# Government of the District of Columbia

#### **MEMORANDUM**

**SUBJECT:** ZC Case No. 24-15 – 901 Monroe Street NE PUD

## Figure 1 | Site Layout

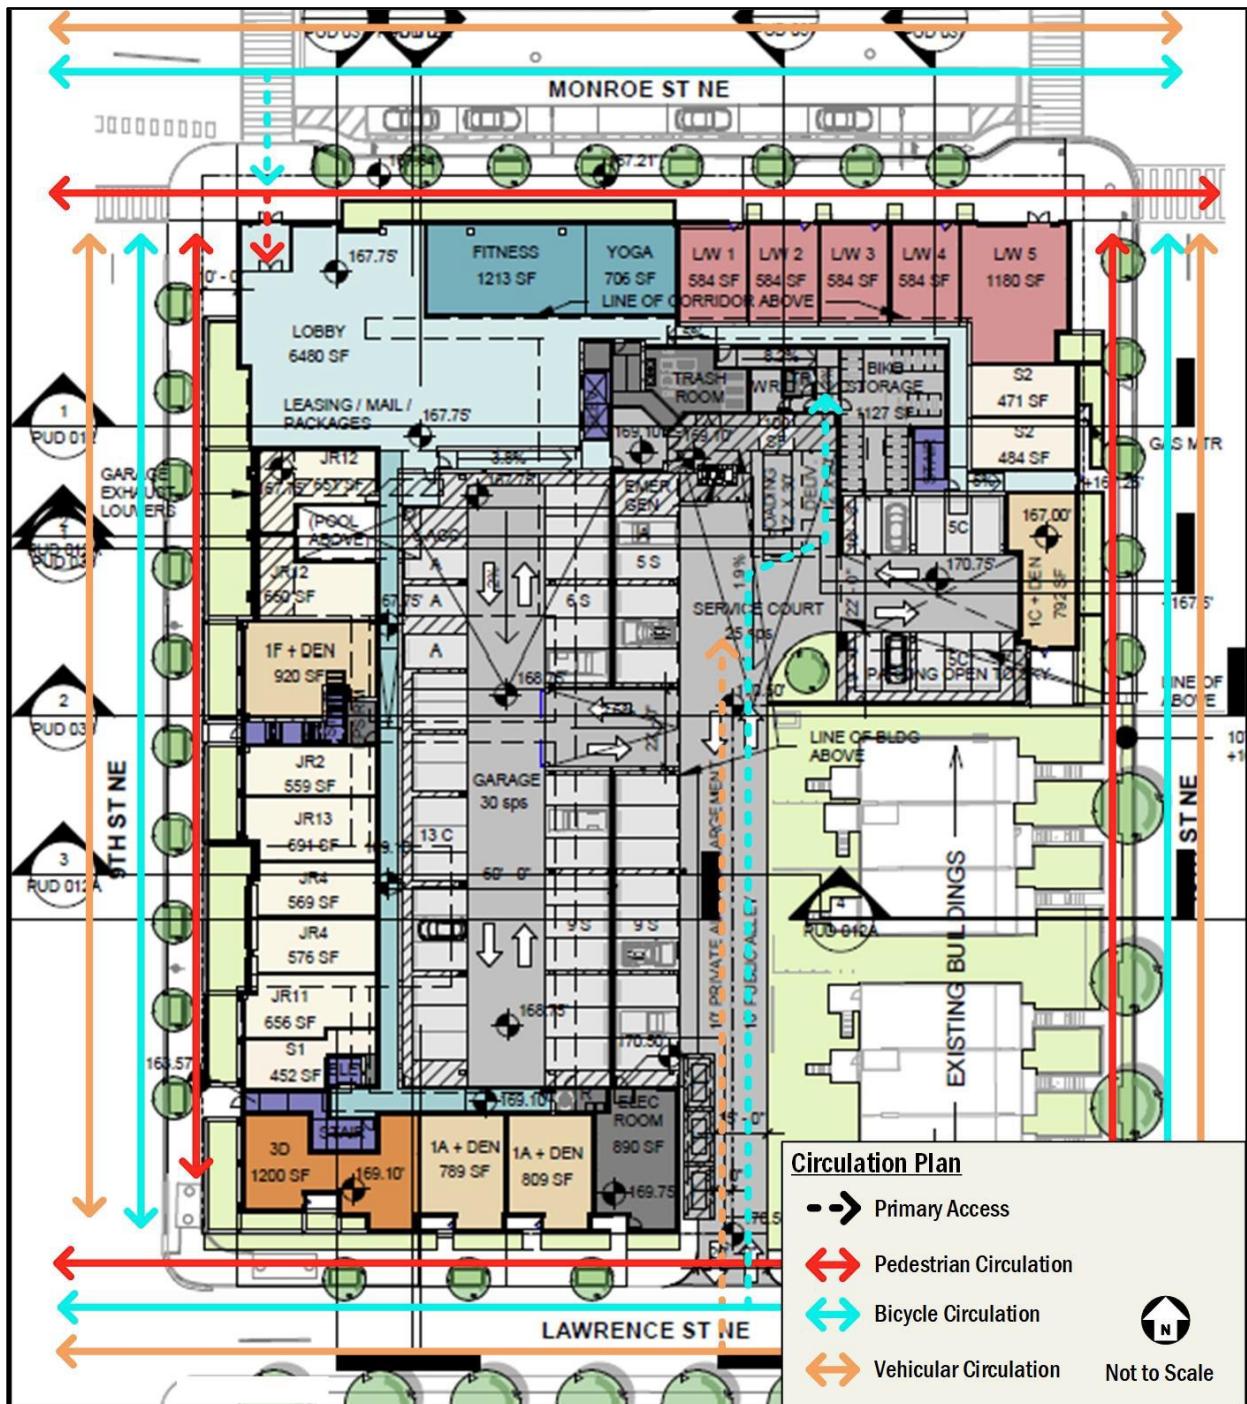
While the preliminary public space plans, shown above in Figure 1, are generally consistent with DDOT standards, there are several considerations that need to be reviewed in greater detail during the public space permitting process:

- The Applicant should implement the following infrastructure improvements in public space, subject to DDOT approval:
  - Add intersection “daylighting” at the four (4) intersections surrounding the project to increase visibility of pedestrians and slow down vehicles traveling to and from the site;

- Construct a concrete protective barrier along the bicycle lane on the south side of Monroe Street between each intersection and the end of the parking lane

- The Applicant should provide a public access easement for the expanded portion of the alley to allow full public use of the alley. The existing utility poles in the alley will need to be relocated in order for the expanded alley to properly function;

- The Applicant should provide a perpetual easement for the portions of sidewalk along Monroe, 9<sup>th</sup>, and 10<sup>th</sup> Streets within private property to meet minimum streetscape designs standards and so that DDOT can provide maintenance;

- The Applicant proposes to install speed bumps in the alley to slow down vehicle traffic entering the site, which DDOT supports, subject to public space permit approval;

- All building entrances must be at grade with the sidewalk so that no stairs or ramps will be necessary in public space;
